# UNITED STATES PATENT AND TRADEMARK OFFICE

APPLICATION NO.	FILING DATE	FIRST NAMED INVENTOR	ATTORNEY DOCKET NO.	CONFIRMATION NO.
10/760,448	01/20/2004	Don Alan Gilliland	ROC920030364US1	9231
30206	7590	10/06/2004	EXAMINER	
IBM CORPORATION				THOMAS, ERIC W
ROCHESTER IP LAW DEPT. 917				ART UNIT
3605 HIGHWAY 52 NORTH				PAPER NUMBER
ROCHESTER, MN 55901-7829				2831

<b>Office Action Summary</b>	<b>Application No.</b>	<b>Applicant(s)</b>
	10/760,448	GILLILAND ET AL.
	Examiner Eric W Thomas	Art Unit 2831

## DETAILED ACTION

302

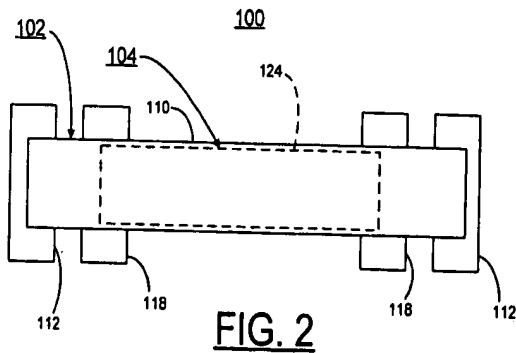
2. The drawings are objected to because reference number 302 is not referencing anything.

Corrected drawing sheets in compliance with 37 CFR 1.121(d) are required in reply to the Office action to avoid abandonment of the application. Any amended replacement drawing sheet should include all of the figures appearing on the immediate prior version of the sheet, even if only one figure is being amended. The figure or figure number of an amended drawing should not be labeled as "amended." If a drawing figure is to be canceled, the appropriate figure must be removed from the replacement sheet, and where necessary, the remaining figures must be renumbered and appropriate changes made to the brief description of the several views of the drawings for consistency. Additional replacement sheets may be necessary to show the renumbering of the remaining figures. The replacement sheet(s) should be labeled "Replacement Sheet" in the page header (as per 37 CFR 1.84(c)) so as not to obstruct any portion of the drawing figures. If the changes are not accepted by the examiner, the applicant will be notified and informed of any required corrective action in the next Office action. The objection to the drawings will not be held in abeyance.
